Item Name: Quick Release Basket and Long Cargo Tube Mounting Provisions, Fits LH or RH

DART SERVICE INSTRUCTION

**TO AMEND INSTALLATION INSTRUCTIONS D350-607-3 Rev.D,
INSTALLATION INSTRUCTIONS D350-607-4 Rev. C AND
INSTRUCTIONS FOR CONTINUED AIRWORTHINESS ICA-D350-607 REV. 6**
REF TCCA STC: SH94-14
REF FAA STC: SR00213NY
REF EASA STC: EASA.10016996
REF BRAZILIAN STC: 2007S03-03/-04/-05/-06

FIGURE 1: INSTALLATION OF D4775-041 FWD STRUT

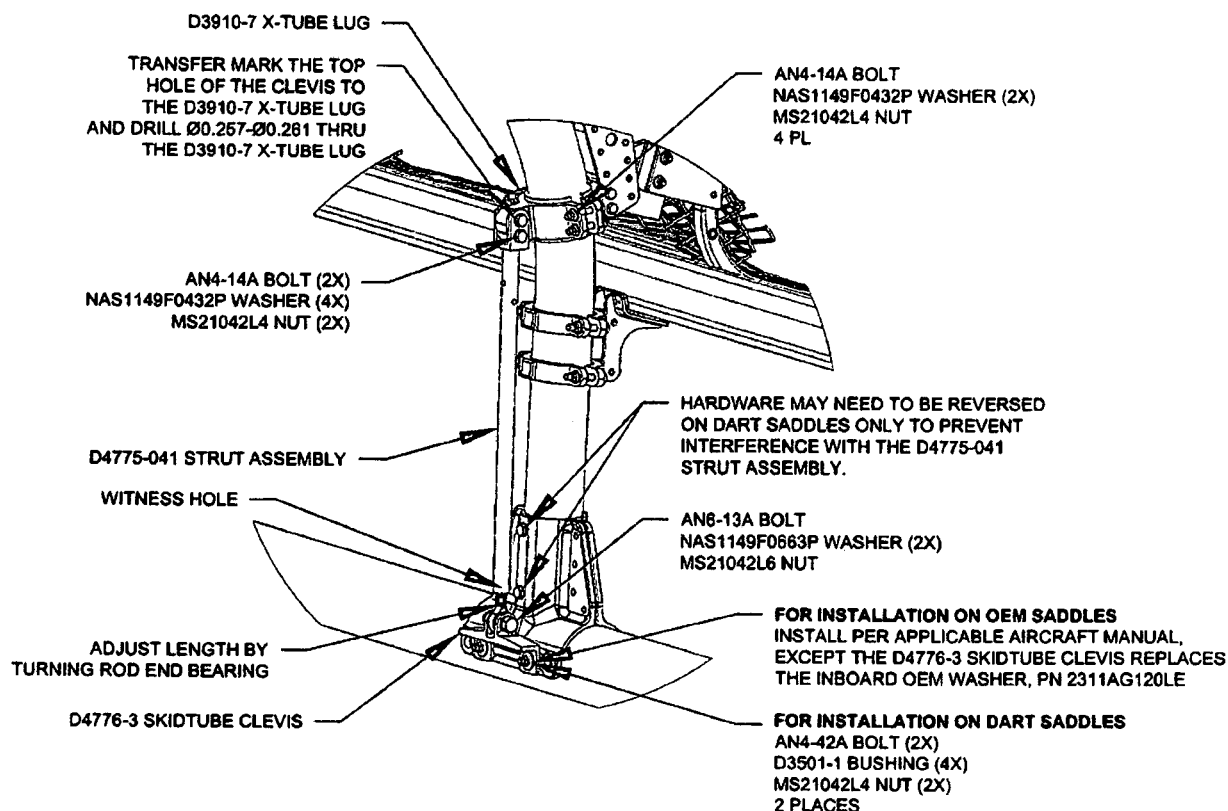
- 3.1 Substitute the Forward Lower D3910-5 X-Tube Lug with the D3910-7 X-Tube Lug as shown in Figure 1.
- 3.2 Install the forward D4775-041 Strut Assembly. Transfer mark from the upper hole on the clevis of the D4775-041 Strut Assembly to the D3910-7 X-tube Lug and drill thru the lug $\varnothing 0.257$ - $\varnothing 0.261$ as shown in Figure 1. Touch up chemical conversion coating per MIL-DTL-5541. Check the witness holes located at the bottom end of the D4775-041 Strut Assemblies to ensure that the thread from the rod end extends past the witness hole.
Torque MS21042L4/-4 nuts to 50-70 in-lbs (5.7-7.9 N-m). Torque MS21042L6/-6 nuts to 160-190 in-lbs (18.1-21.5 N-m).
- 3.3 Complete the installation in accordance with Installation Instructions D350-607-3 Rev. D or D350-607-4 Rev. C.
